**CEDAR CREEK STREAM AND WETLAND RESTORATION
PROJECT
MONITORING REPORT
MONITORING YEAR 4
FINAL**

SAMPSON COUNTY, NORTH CAROLINA
CONTRACT No. 005011 - PROJECT No. 95718
USACE ACTION ID No. 2012-00389 – NCDWR PROJECT No. 2013-0186

RE: Cedar Creek Stream and Wetland Restoration Site: MY4 Monitoring Report (NCDMS ID 95718)

Listed below are comments provided by DMS on December 14, 2018 regarding the Cedar Creek Stream and Wetland Restoration Site: Year 4 Monitoring Report and RES' responses.

Figure 3b.
Cedar Creek
Restoration Project
MY4 2018
Current Conditions
Plan View

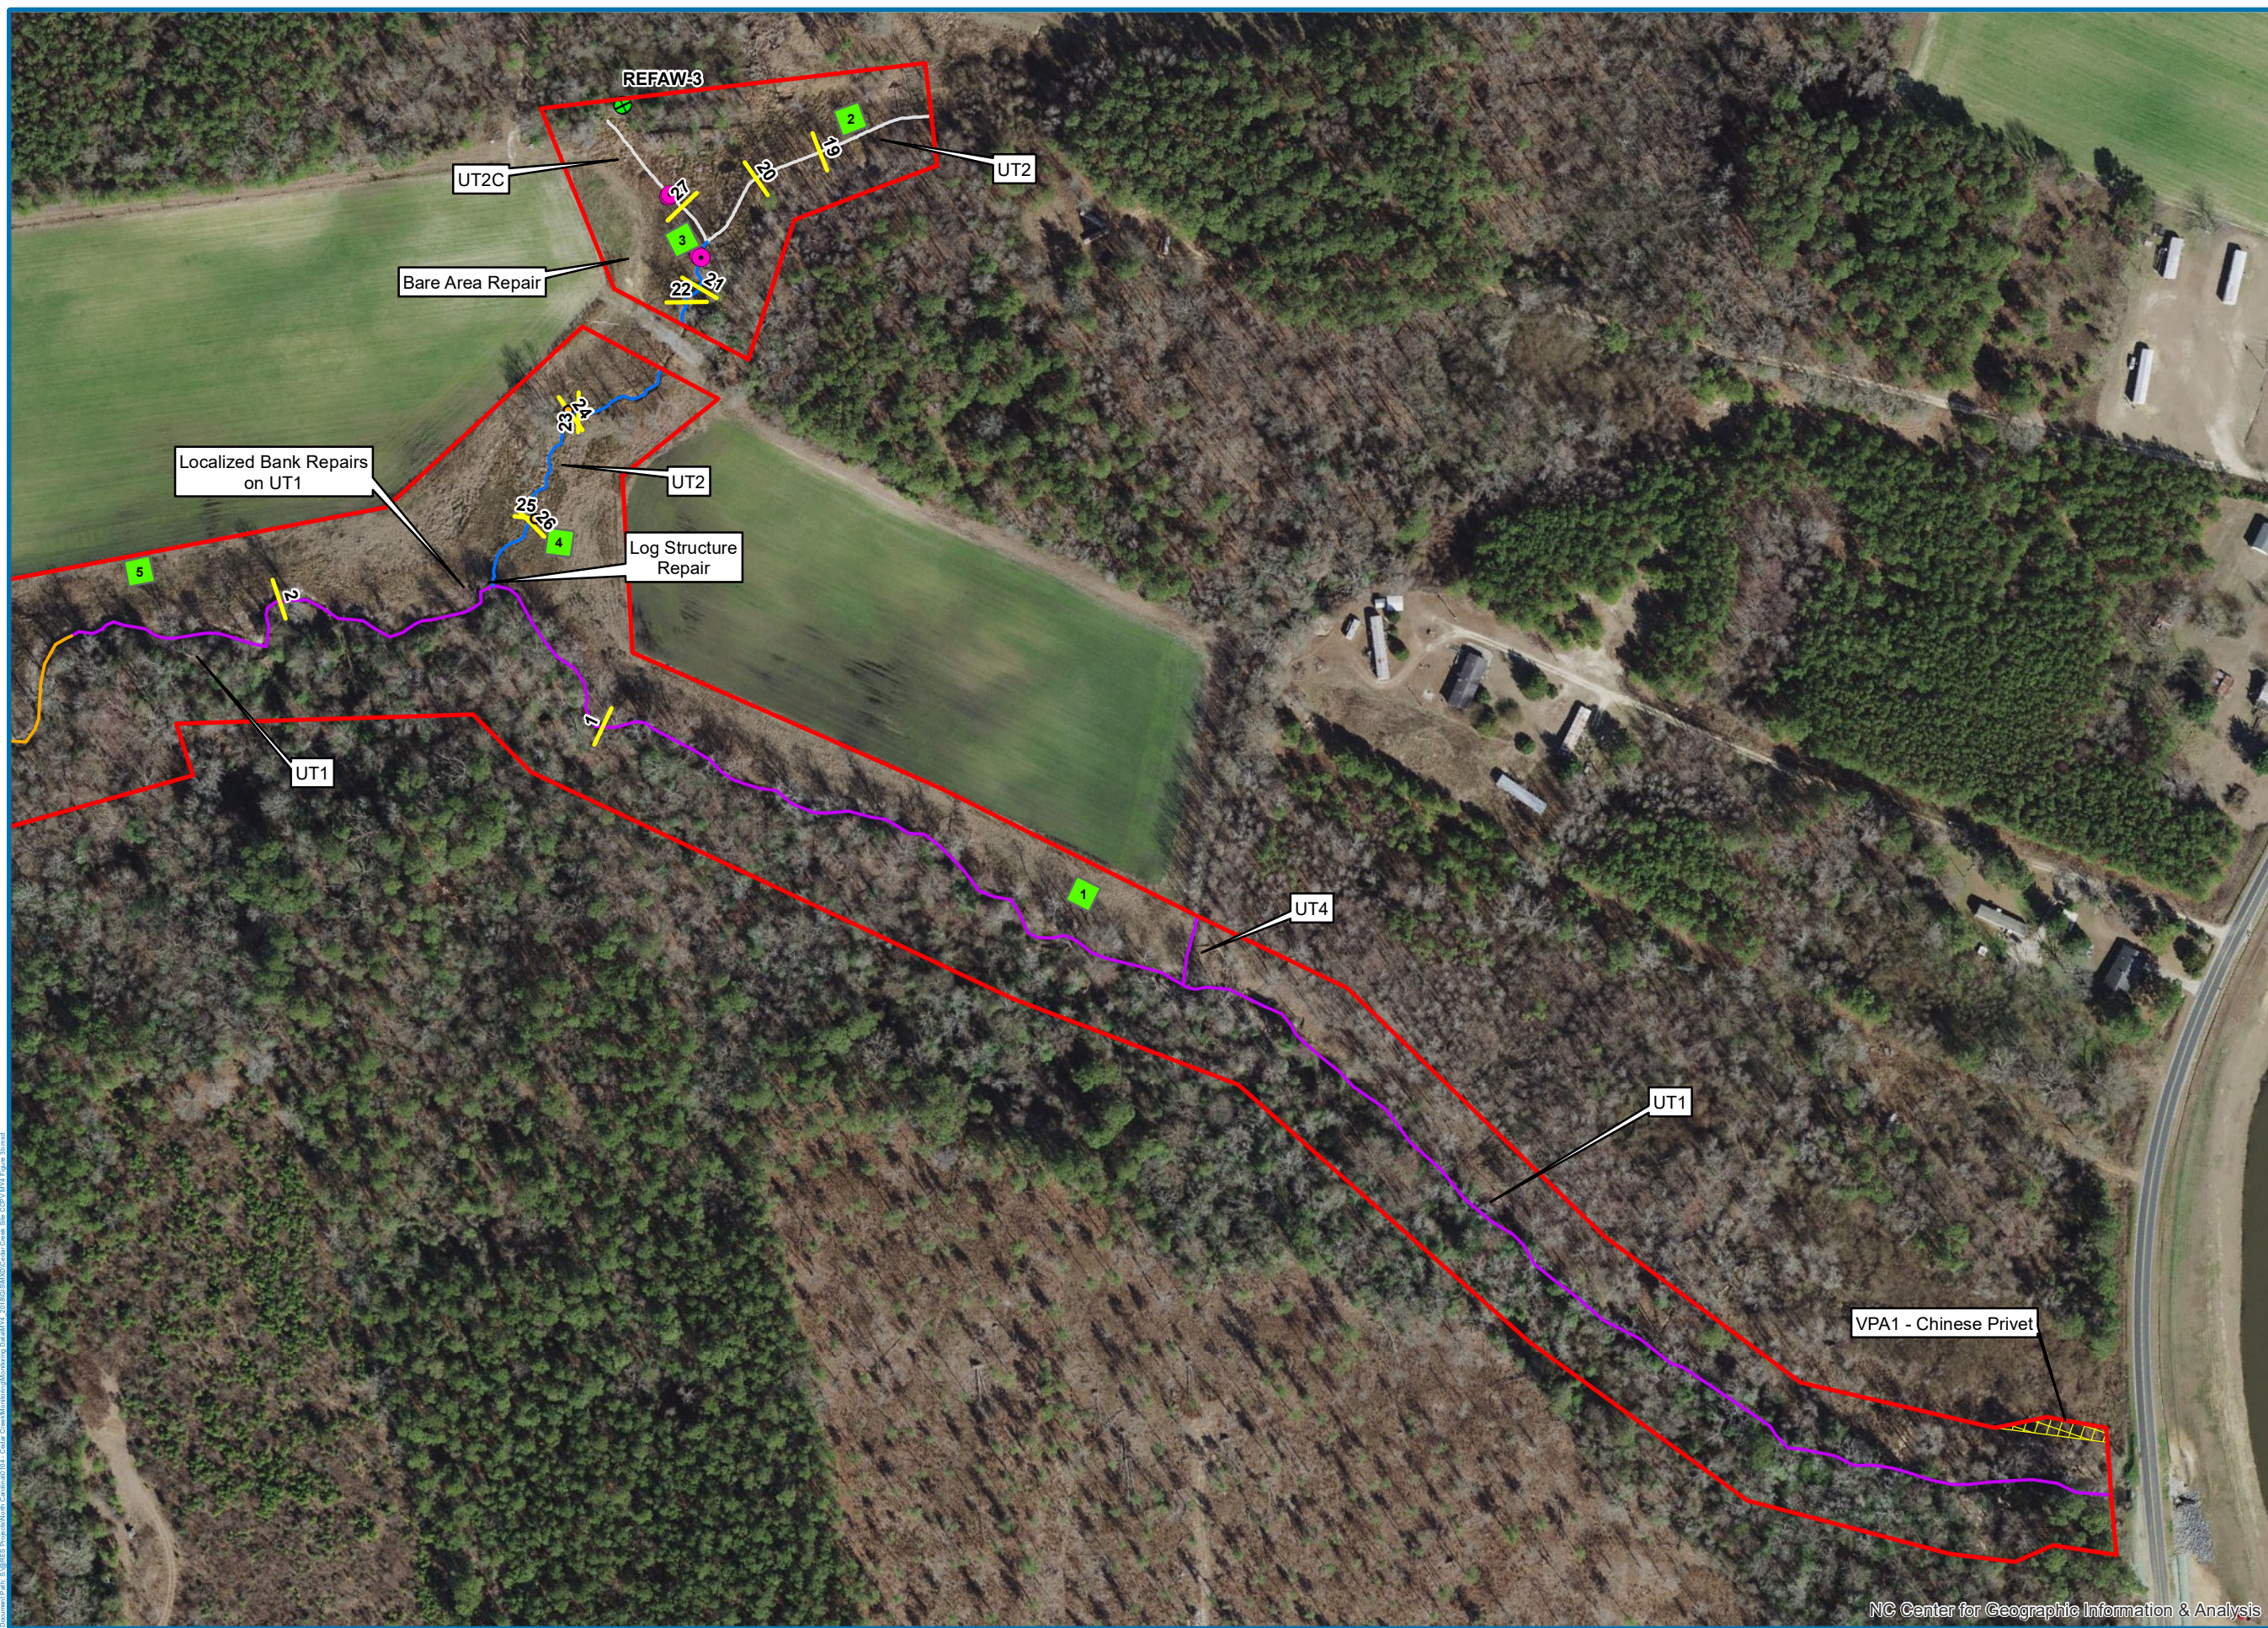
6. **Appendix B:**
 - a. CCPV: The locations of bank pins are not shown. Please show on appropriate figure(s).
Done.
 - b. Table 5 (all): Provide description of red asterisk as footnote or remove if not necessary in both hardcopy and digital files.
The asterisks have been removed.

- c. Table 6: Explain why there is nothing discussed on the Invasive Area of Concern row when you discuss invasive vegetation in the report narrative, show it on the CCPV and list it in Table 7.
The invasive species area has been quantified on Table 6, displayed on the CCPV, and listed in Table 7.
